ADDENDUM NO. 2

DATE OF ISSUANCE: May 13, 2025

PROJECT: 2025 FEMA Safe Room Addition
Crawford County High & Middle School
1130 S. State Road 66
Marengo, IN 47140

ARCHITECT'S PROJECT NO.: 22-131.000

2.02 SIGN SCHEDULE

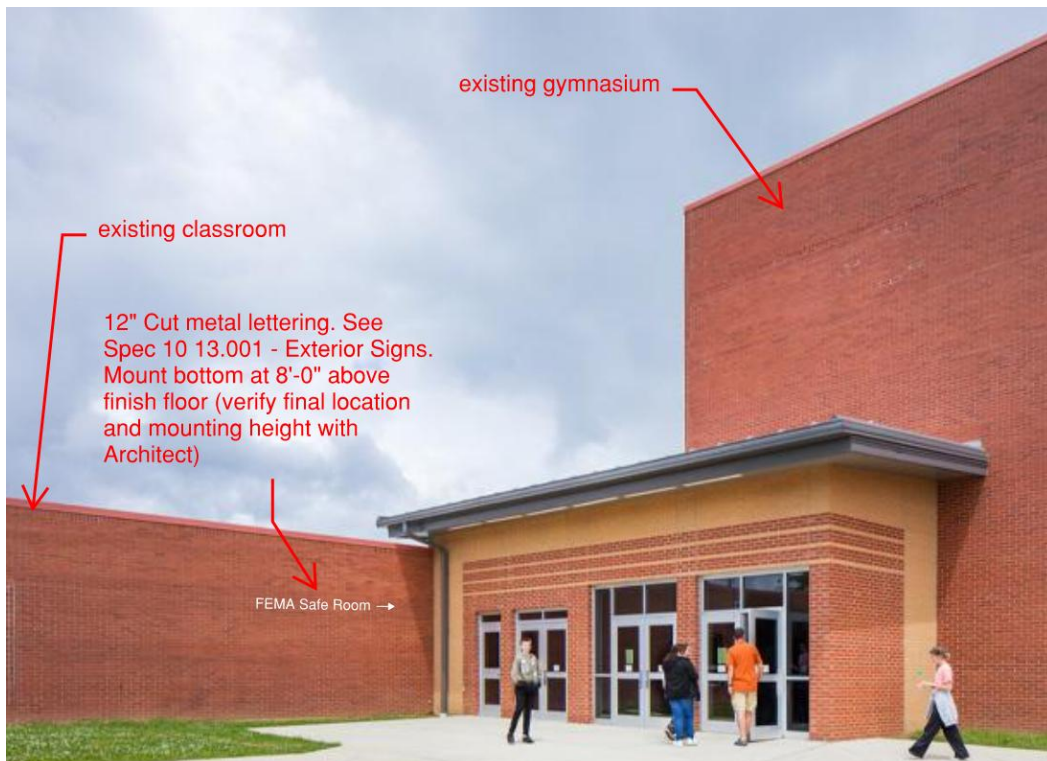
- A. Material: Cut Metal Lettering
- Text: FEMA Safe Room (with arrow symbol)
- Location: Mount on existing exterior brick veneer wall.
See conceptual image below (west of existing gymnasium).
Verify final location with Architect and Owner.
- Size: 12" upper case and associated lower case.
- Font: Helvetica.

- B. Material: Cut Metal Lettering
- Text: FEMA Safe Room (with arrow symbol)
- Location: Mount on existing exterior brick veneer wall.
See conceptual image below (east of existing fieldhouse entry).
Verify final location with Architect and Owner.
- Size: 12" upper case and associated lower case.
- Font: Helvetica.

AD2-01

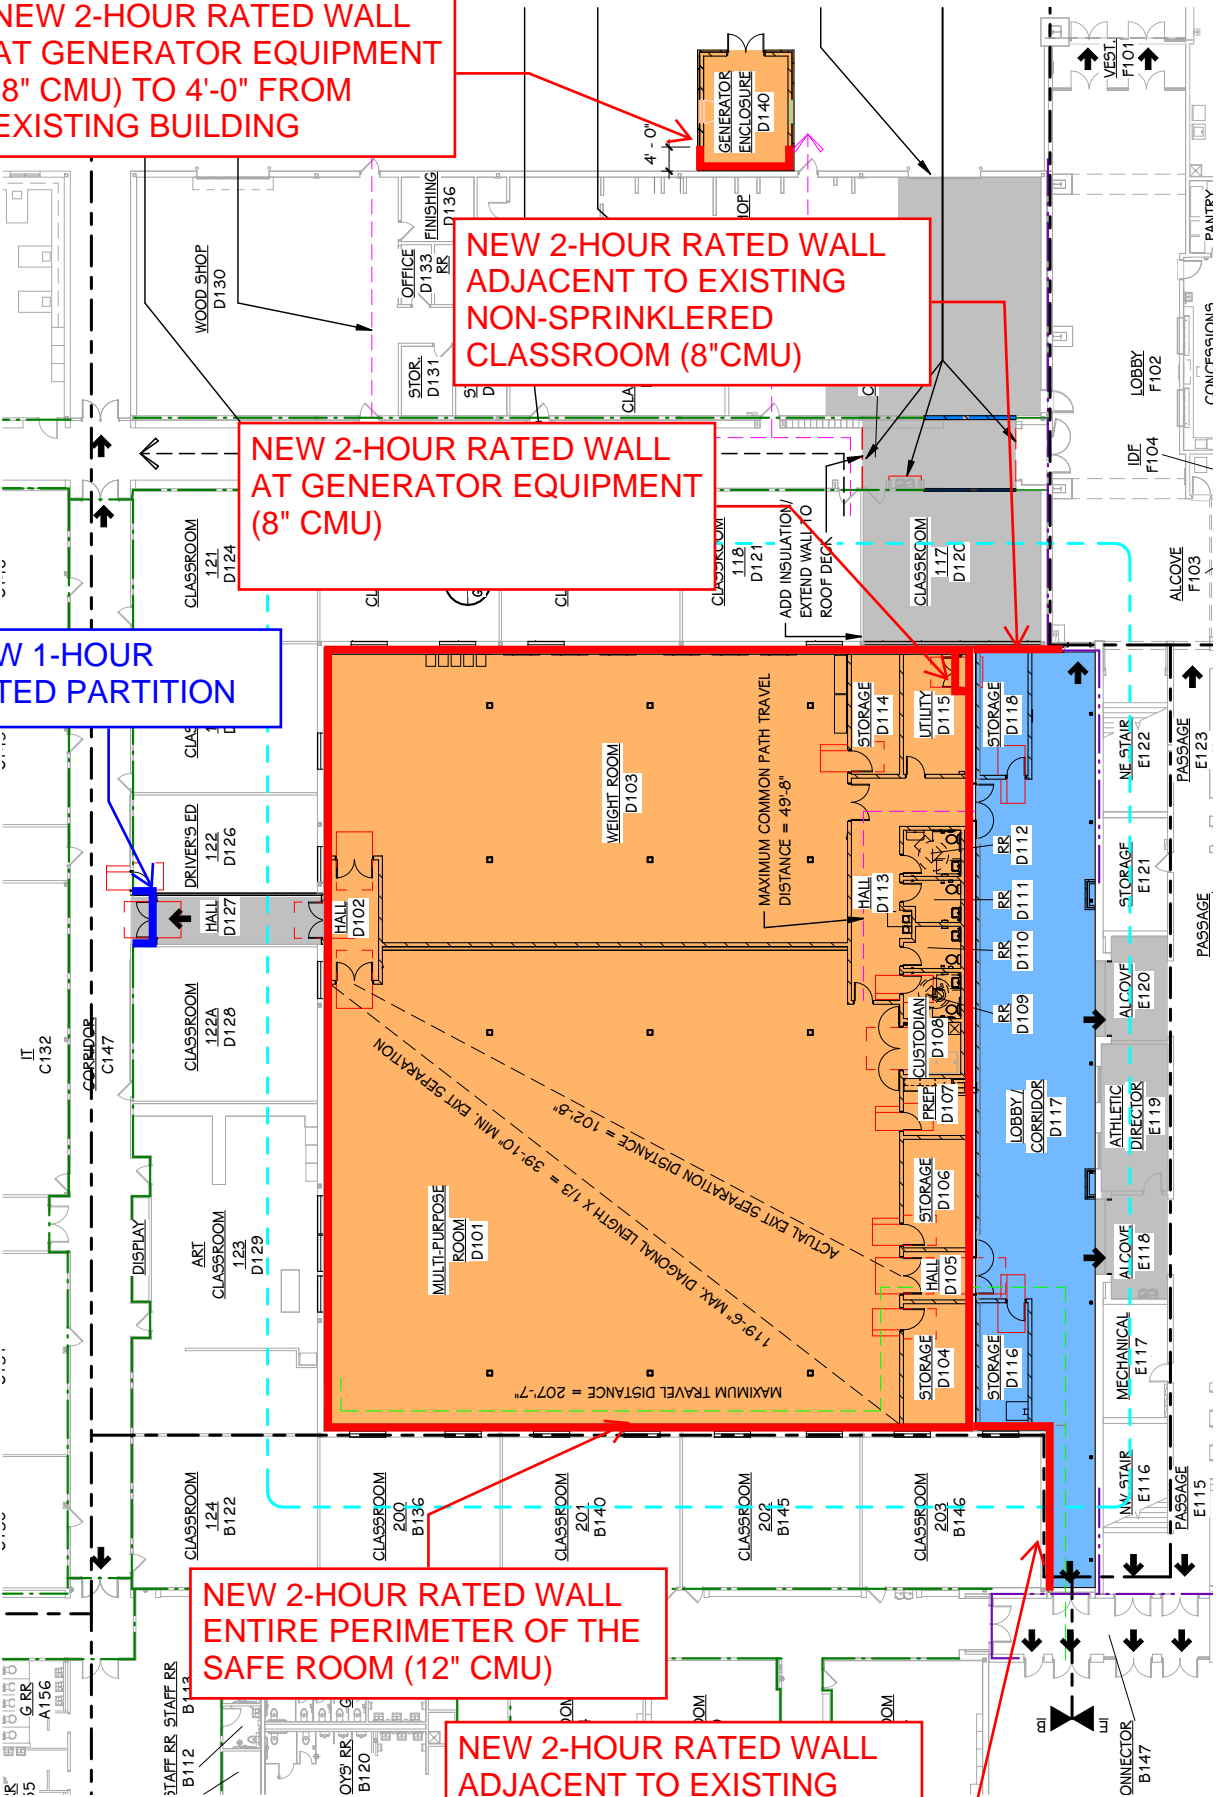
Rated Wall lines did not print properly in many locations. See drawing AD2-01 attached.

All FEMA Safe Room outside perimeter walls are 2-Hour Rated Construction.

The closet in Utility D115 containing generator equipment is 2-Hour Rated Construction.

The FEMA hardened generator enclosure is 2-Hour Rated Construction along the existing building to 4'-0" perpendicular from the face of the existing building (both sides).

At Lobby/Corridor D117, the 8" wall that is part of the non-hardened (traditional) construction is 2-Hour Rated Construction from the corner of the FEMA Safe Room Storage D104 to Connector B147 (existing 2-Hour rated construction). Connector B147 is not sprinkled. The existing classrooms are not sprinkled.

At Lobby/Corridor D117, the 8" wall that is part of the non-hardened (traditional) construction is 2-Hour Rated Construction from the corner of the FEMA Safe Room Utility D115 to the existing fire wall at Lobby F102. The existing classrooms are not sprinkled. Lobby F102 is sprinkled.

At Corridor C147, the new metal stud and gypsum board walls at new Hall D127 is a 1-Hour Rated partition to maintain the existing 1-Hour Rated Corridor.

NEW CONSTRUCTION RATED WALLS

NEW 2-HOUR RATED WALL AT GENERATOR EQUIPMENT (8" CMU) TO 4'-0" FROM EXISTING BUILDING

NEW 2-HOUR RATED WALL ADJACENT TO EXISTING NON-SPRINKLERED CLASSROOM (8"CMU)

NEW 2-HOUR RATED WALL AT GENERATOR EQUIPMENT (8" CMU)

NEW 1-HOUR RATED PARTITION

NEW 2-HOUR RATED WALL ENTIRE PERIMETER OF THE SAFE ROOM (12" CMU)

NEW 2-HOUR RATED WALL ADJACENT TO EXISTING NON-SPRINKLERED CLASSROOM (8"CMU)
